FINAL PRODUCT/PROCESS CHANGE NOTIFICATION #16669Generic Copy

Issue Date: 23-Jun-2011**TITLE:** Qualification of Serial I2C EEPROM devices CAT24C128 and CAT24C256 for fabrication at ON Semiconductor's Gresham, Oregon Wafer Fab**PROPOSED FIRST SHIP DATE:** 01-Oct-2011**AFFECTED CHANGE CATEGORY(S):** CAT24C128 and CAT24C256 (all Packages, all Temperatures)**FOR ANY QUESTIONS CONCERNING THIS NOTIFICATION:**Contact your local ON Semiconductor Sales Office or Denisa Stefan <denisa.stefan@onsemi.com>**SAMPLES:** Samples available per "[Affected Device List](#)" table on Page 4. Contact your local ON Semiconductor Sales Office.**ADDITIONAL RELIABILITY DATA:** AvailableContact your local ON Semiconductor Sales Office or Tony Luciani <tony.luciani@onsemi.com>**NOTIFICATION TYPE:**

New Gresham die CAT24C128 Rev C

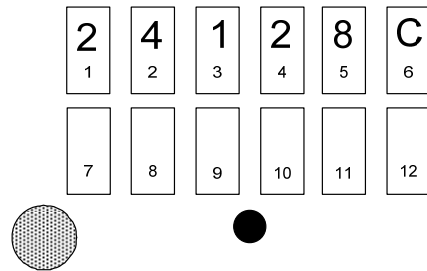
- 1-5: Device name(5 char)
- 6: Production Revision
- 7: Assembly location
- 8: Production Year
- 9: Production Month
- 10-12: Assembly Lot Number

New Gresham die CAT24C128YI-G Rev C

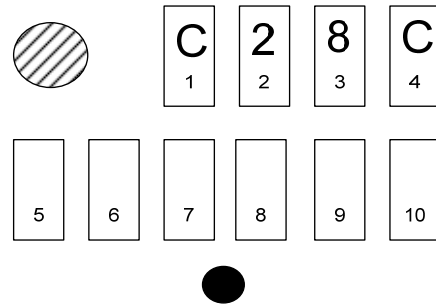
- 1-3: Device name
- 4: Product Revision
- 5: Assembly location code
- 6: Production Year
- 7: Production Month
- 8-10: Assembly lot number
- :Pb-free microdot

New Gresham die CAT24C128LI-G Rev C

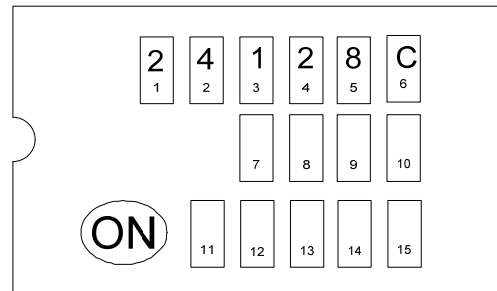
- 1-5: Device name
- 6: Product Revision
- 7: Assembly location code
- 8-10: Assembly lot number
- 11-12: Production Year
- 13-14: Production Week
- 15: Pb-free designator
